FORM APPROVED
OMB NO. 1004-0135
Expires: July 31, 2010**SUNDRY NOTICES AND REPORTS ON WELLS**
*Do not use this form for proposals to drill or to re-enter an abandoned well. Use form 3160-3 (APD) for such proposals.*5. Lease Serial No.
NMNM02965A

☒ Oil Well ☐ Gas Well ☐ Other8. Well Name and No.
THOR 21 FED COM 703H

EOG Resources requests an amendment to our approved APD for this well to reflect a change in casing design and TVD.

Sundry NOI - Casing Change - Thor 21 Fed Com 703H & 704H

**Lea County, New Mexico
Proposed Wellbore
Revised 3/29/16
API: 30-025-42815**

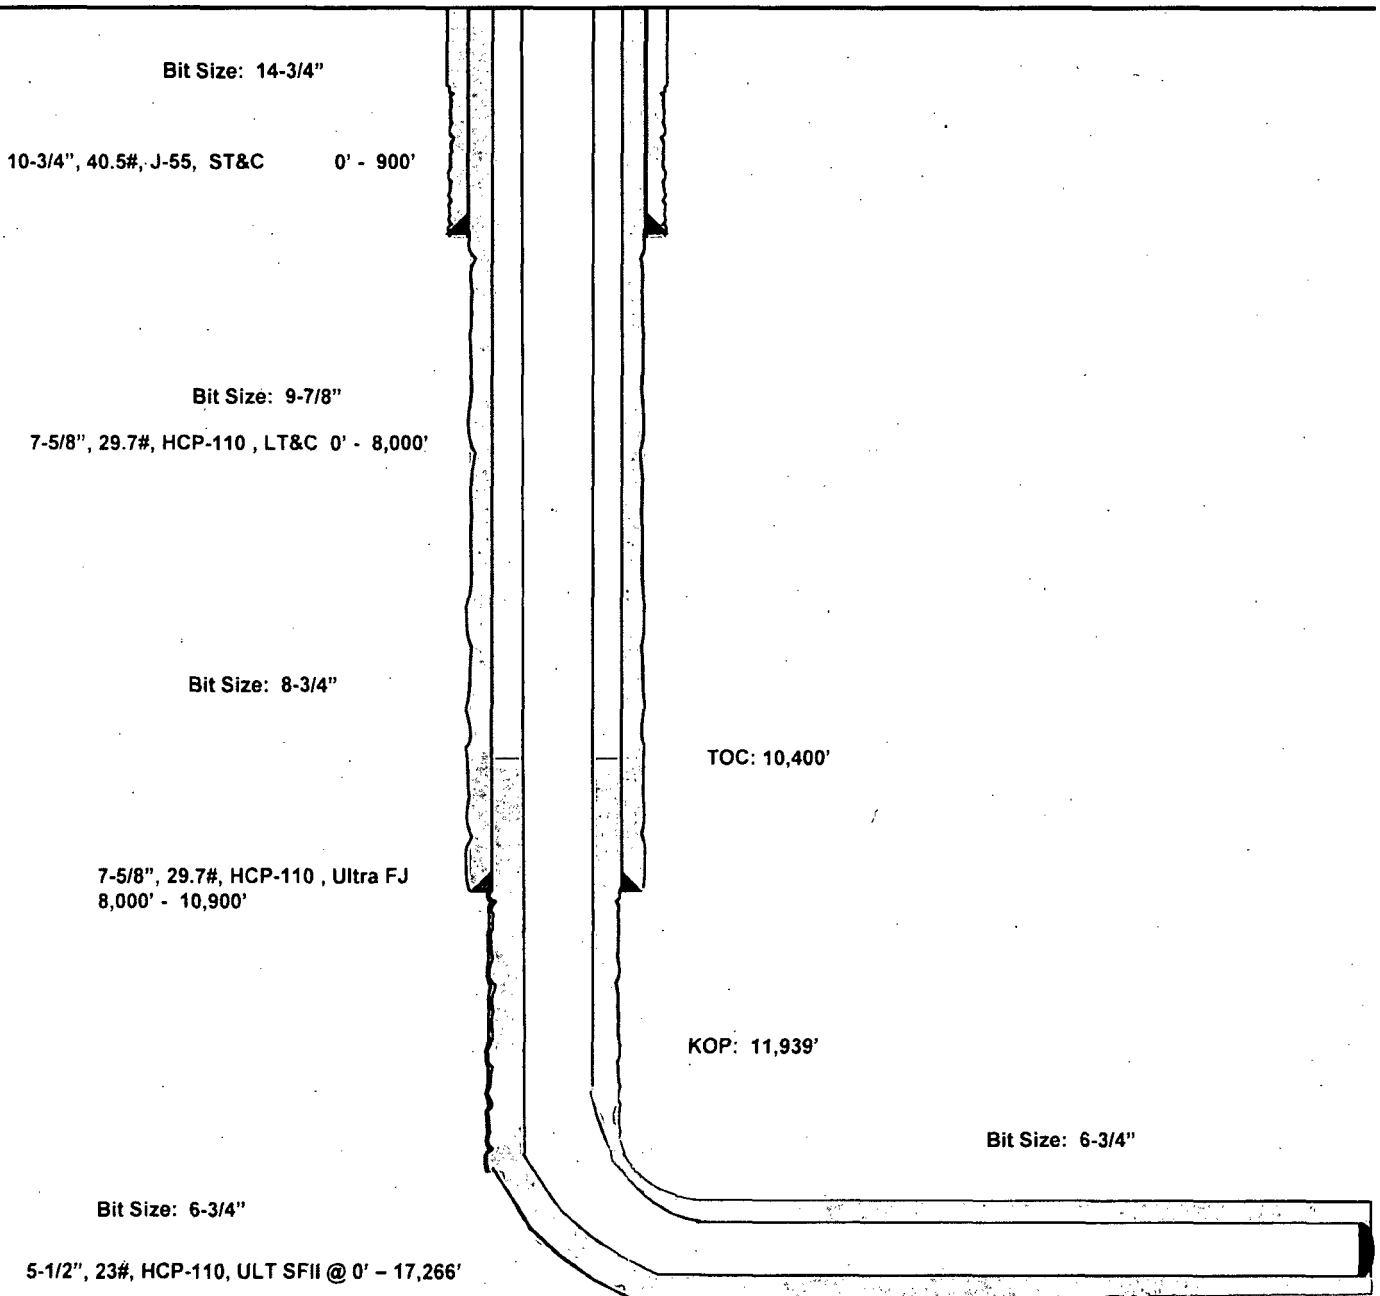
Changing TVD from 12420' TO: 12520' TVD, 17266' MD.

I am reviewing on the 703H, I was doing my calculations and I noticed a 10M BOP & BOPE system is actually required below the intermediate casing. As of now the the Drilling Program only proposes a 5M system.

$12,520 \text{ [Max TVD in Sundry]} * (12.00 \text{ [Max MW at that Depth in Sundry]} / 19.25 - 0.22 \text{ [Assumed Gas Gradient]}) = 5045.543 > 5000$. Therefore BOP & BOPE needs to be rated, as well as tested, to a 10M System.

Because of this, I am requesting EOG to review the BOP and BOPE for this notification to address this issue.

We will resubmit and change the anticipated mud weight range to 10.0 to 11.5 ppg. Normally we drill these laterals with mud weights ranging from 9.5 to 11.5 ppg. Almost always we get it done with 10.5 ppg or less.

So the 11.5 ppg maximum anticipated MW keeps us below the 5000 psi shut in surface pressure scenario.

I'm very comfortable with this. All of our rigs are equipped with 10,000 psi BOPs and chokes. The only piece of equipment that is not rated for 10,000 psi is the annular BOP.
